Service Bulletin

Subject: Squeak Noise from Rear of Vehicle (Lubricate Rear Leaf Springs)

Models: 1999-2007 Chevrolet Silverado (Classic)
2007-2012 Chevrolet Colorado
2007-2015 Chevrolet Silverado
2015 Chevrolet Colorado
1999-2007 GMC Sierra (Classic)
2007-2012 GMC Canyon
2007-2015 GMC Sierra
2015 GMC Canyon
2007-2010 HUMMER H3, H3T

This Bulletin has been revised to add the 2015 Model Year Colorado/Canyon. Please discard Corporate Bulletin Number 06-03-09-004F.

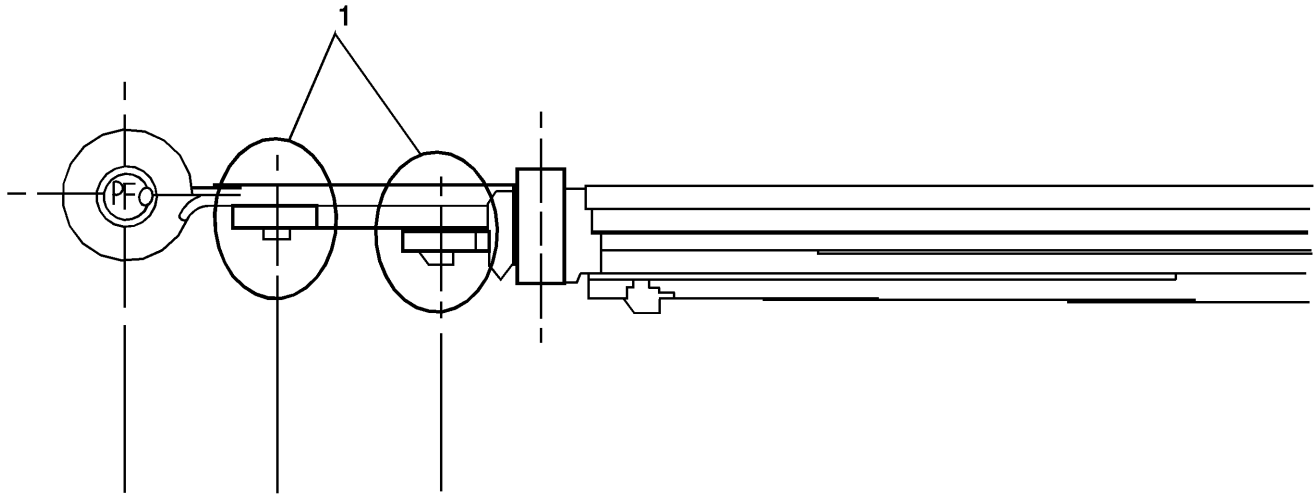
5. Apply a liberal amount of grease, P/N♦12345996 (in Canada, use P/N♦10953501), both underneath and on top of the front and rear tip inserts for the #2 and #3 leaves, as indicated below. A screwdriver can be used to gently pry up the tip insert; however, a rag around the screwdriver must be used to prevent damage to the spring. Use a flat-bladed tool, such as a gasket scraper to properly distribute the grease.
6. Lower the vehicle to the ground and test drive to verify the repair.
